May 1, 2025

**ADDENDUM NO. 1
TO CONTRACT DOCUMENTS FOR THE
STEVENS CREEK EVELYN FISH PASSAGE PROJECT
Project No. 62084001 Contract No. C0708
Invitation No. VW0565**

Attachment 3: Revised Plans: Sheets G-01, G-02, G-03, -G-04, G-07, G-08, G-10, G-11, D-01, D-02, D-03, D-04, D-06, C-01, C-02, C-03, C-04, C-05, C-06, C-07, C-08, C-09, C-10, C,11

Attachment 2: Revised Plans: Sheets G-01, G-02, G-07, D-03, C-03, C-05, C-07, C-09, and C-11

SHEET CODE:	SHEET NUMBER:
C-07	29

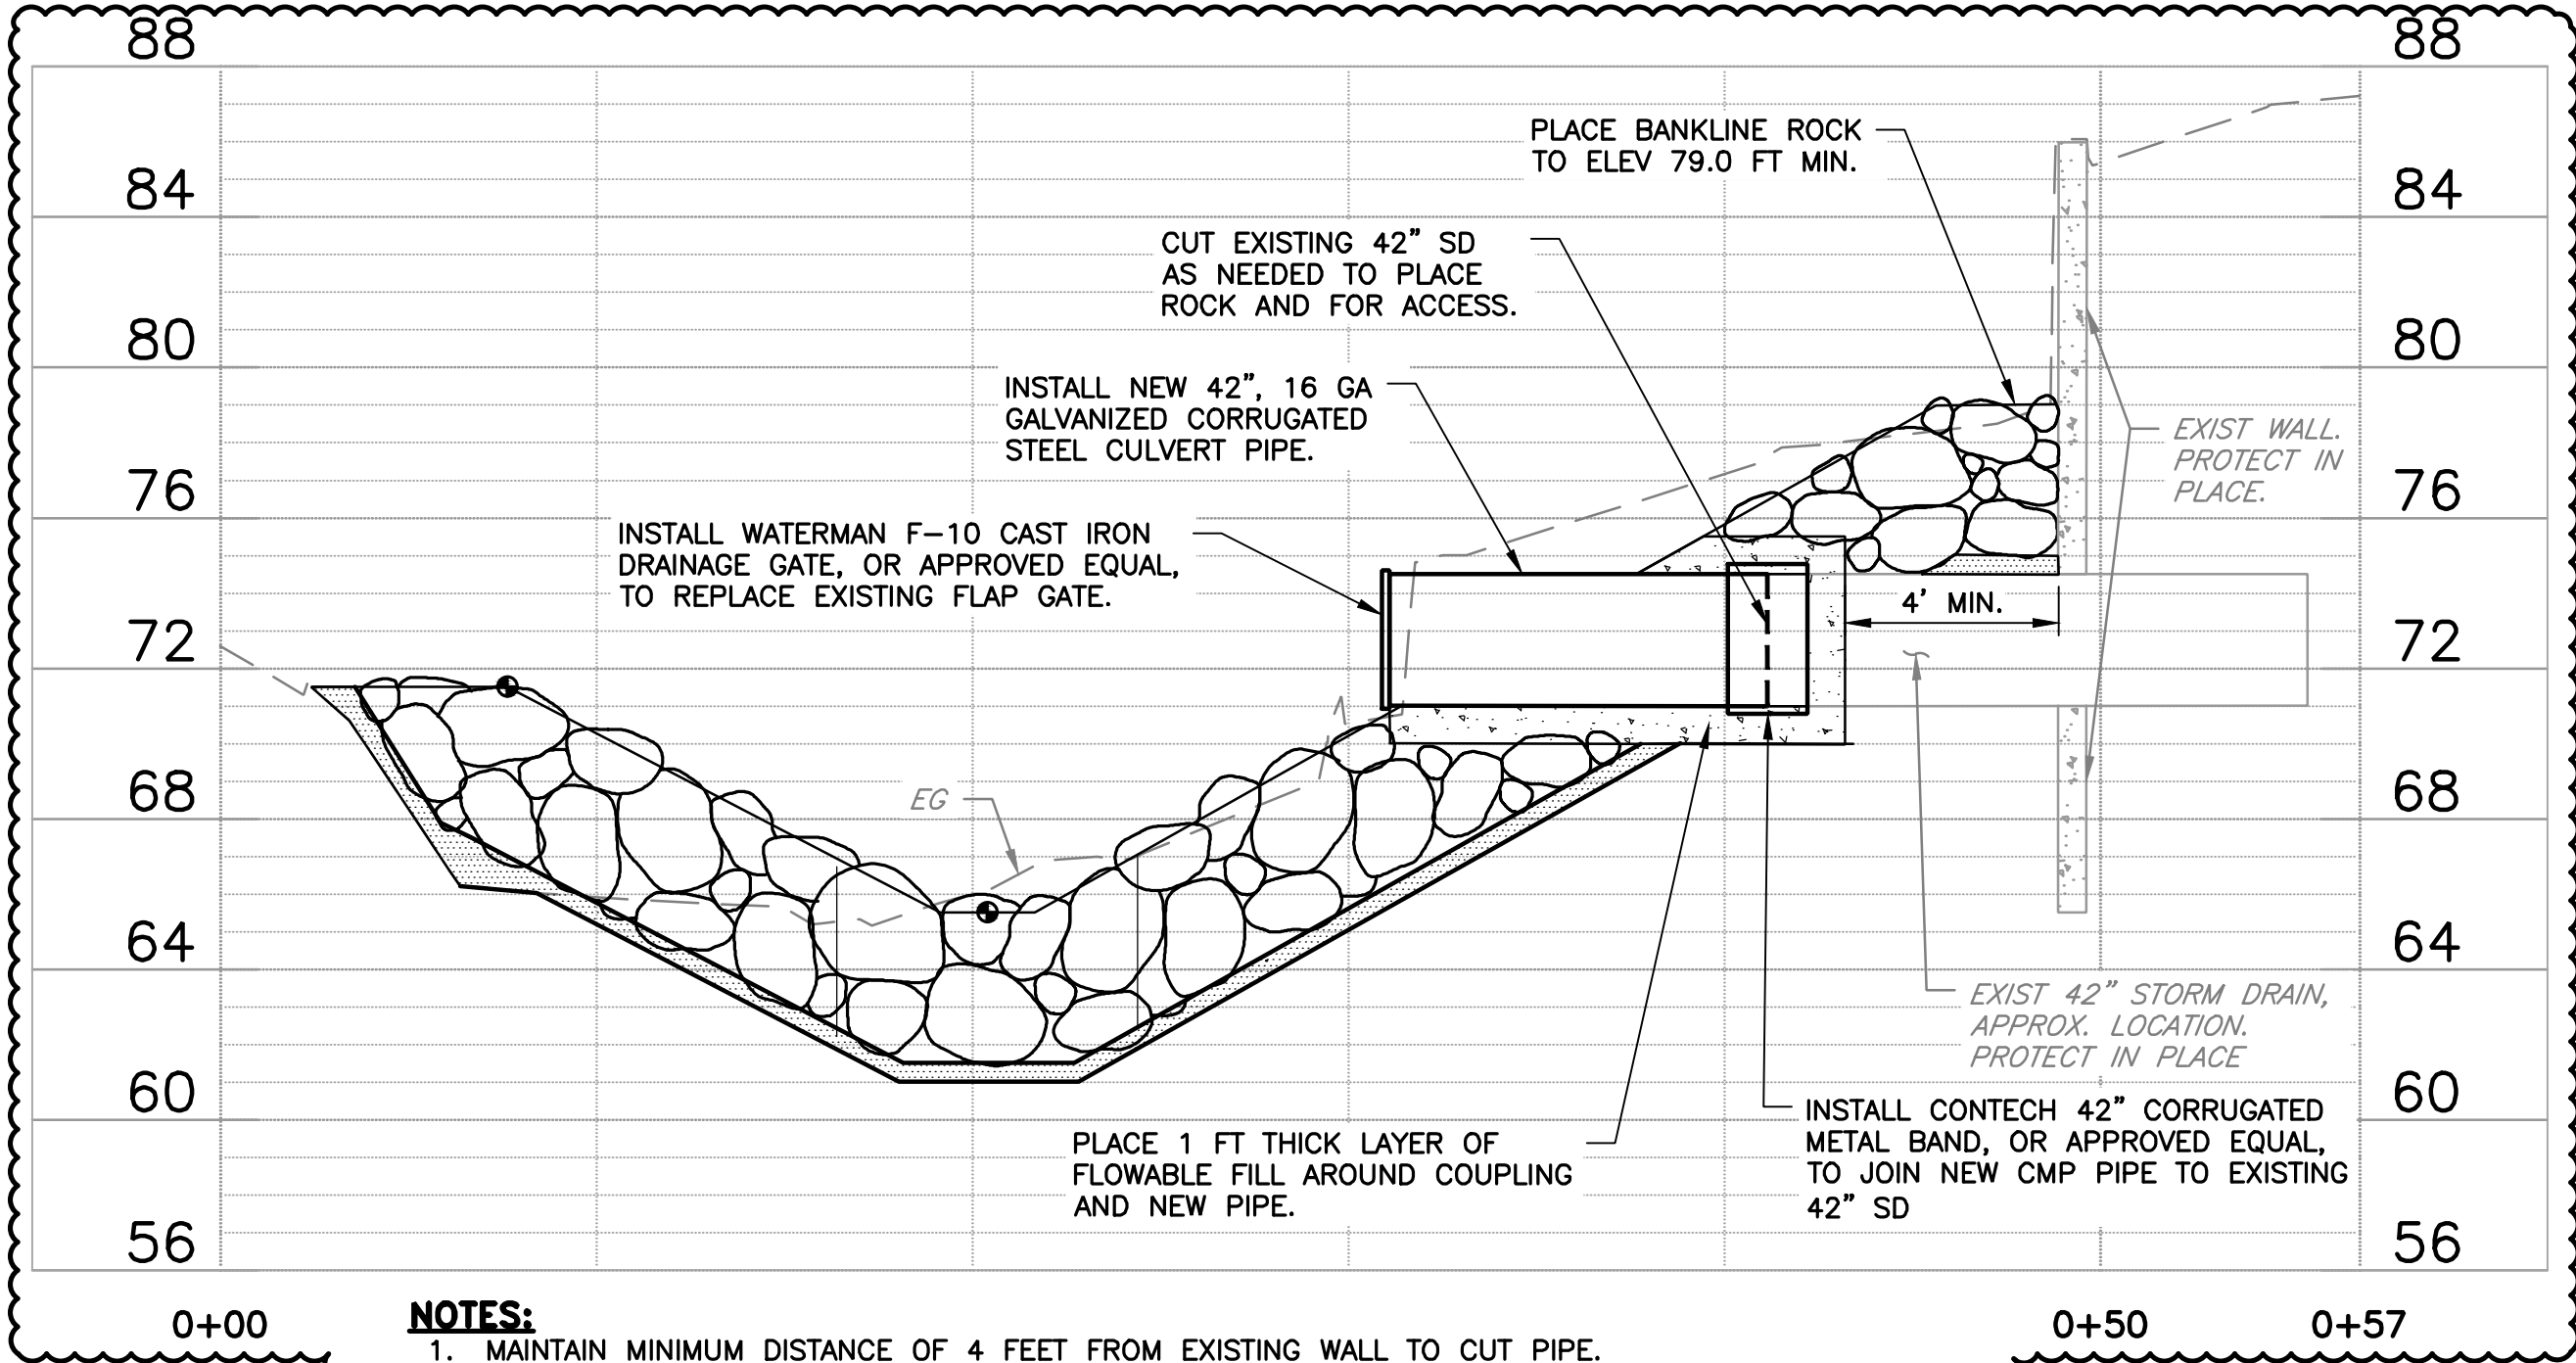
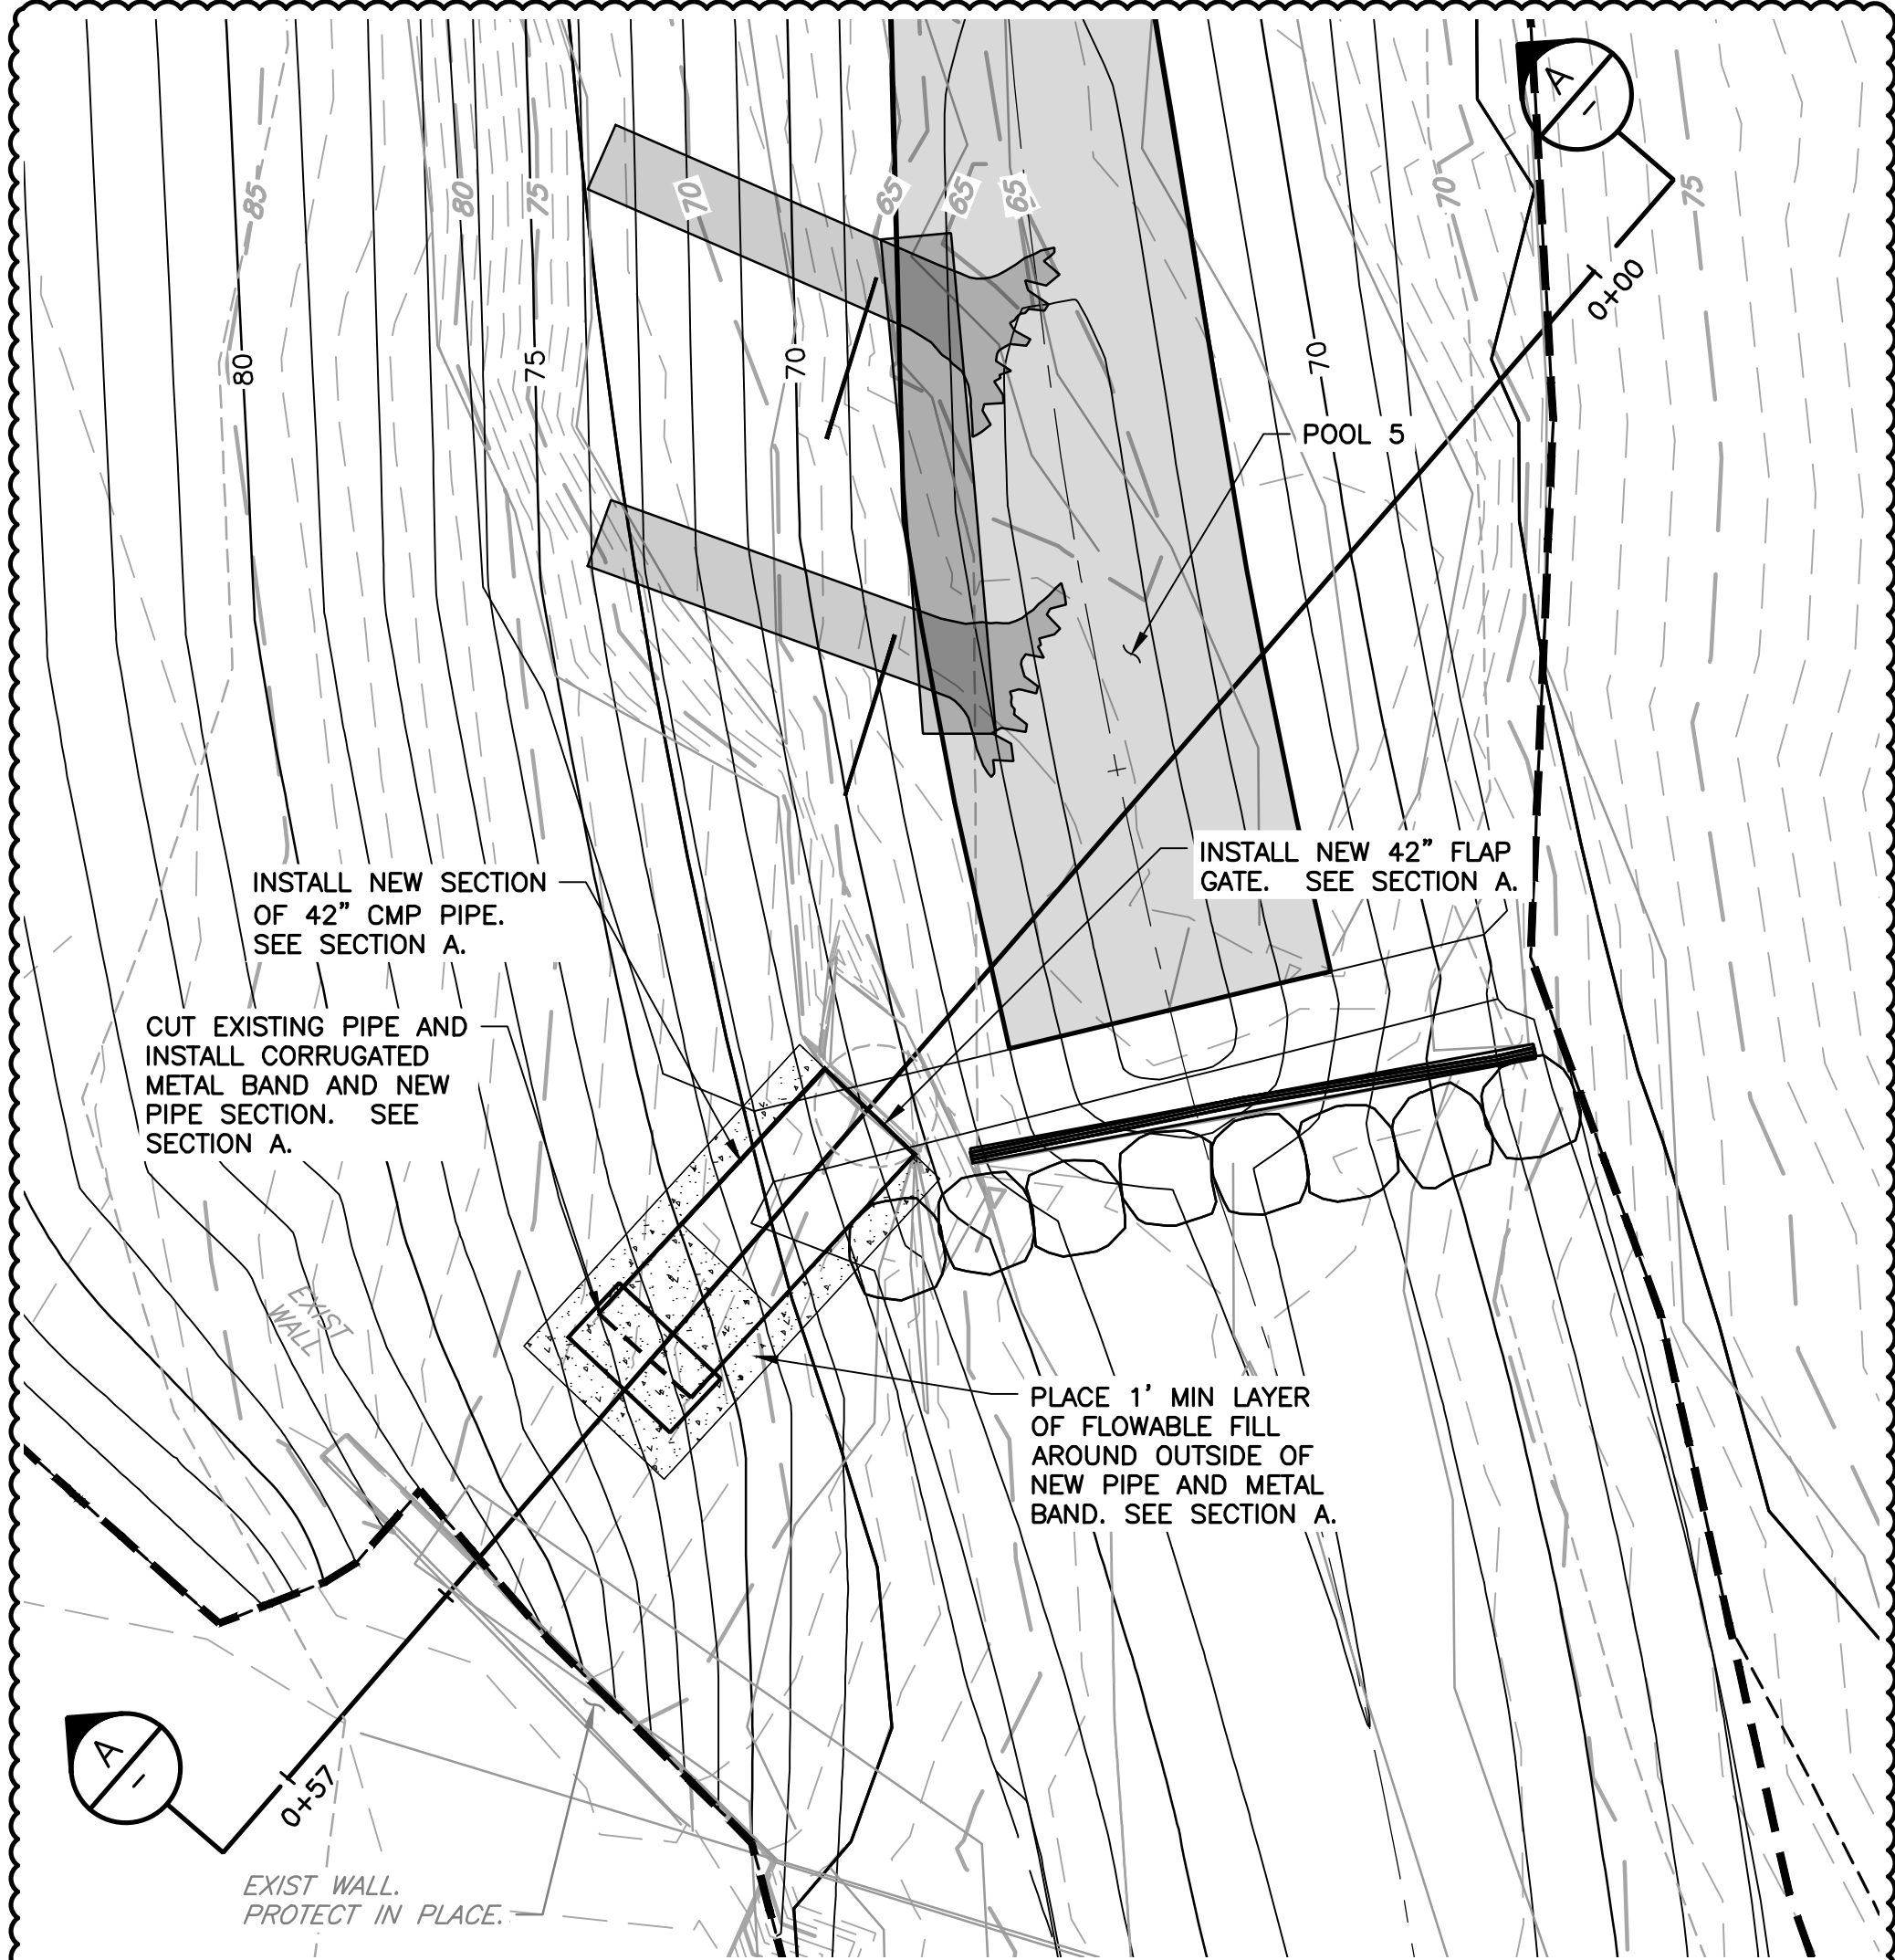
Notes 2.1 and 2.3 of the ESM Specifications shown on Sheet C-07 conflict with each other. Note 2.1 States that all material finer than 6" Diameter shall be rounded Alluvium (River Rock). The table that is included in Note 2.3 states that 25% of the ESM Mix is to be Class 2 Aggregate Base (1-1/2 Inch Maximum). Caltrans defines Class 2 Base as a well graded mixture of crushed angular rock with a maximum aggregate size of 3/4 of an inch. Class 2 aggregate base is not Alluvium, nor does it have a Max Aggregate size of 1-1/2". Can you please clarify the shapes and Gradations of the ESM?

2. **REPLACE** paragraphs A., and B. in Article 27.02.06.02. Materials with:

3. **REPLACE** paragraph C. in Article 27.02.06.02. Materials with:

4. **DELETE** paragraph D. in Article 27.02.06.02. Materials.
5. **REPLACE** Article 28.02.05. Payment, paragraph A from Addendum No. 2 with:
